# Access Compliance Report

## Public Rights-of-Way

### (Pedestrian Signals)

Intersection ID: N/A	Main Street:	Cross Street: N/A	Location: N/A
ADA ID: EB6A982888F3	Signal Type: One Push Button-Non APS	Overall Compliance: No	Severity Score: BTN 1: N/A BTN 2: N/A No BTN: N/A
Codes/Mitigation Info/Possible Solution		Field Measurements/Component Compliance

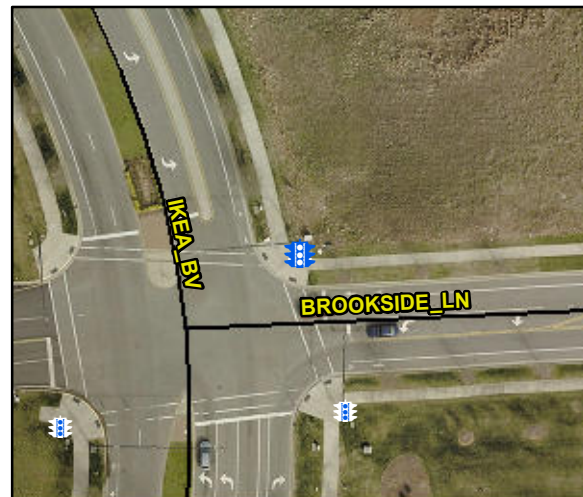
Surveyor Notes: TEXT HT 7/16

PROW/ADA: R410.6, TMUTCD 4e.08, R404.2, R406.2, R404.7.3

Possible Solutions: Replace Signal Push Button With APS Button on New Post. Remove & Replace Sign.
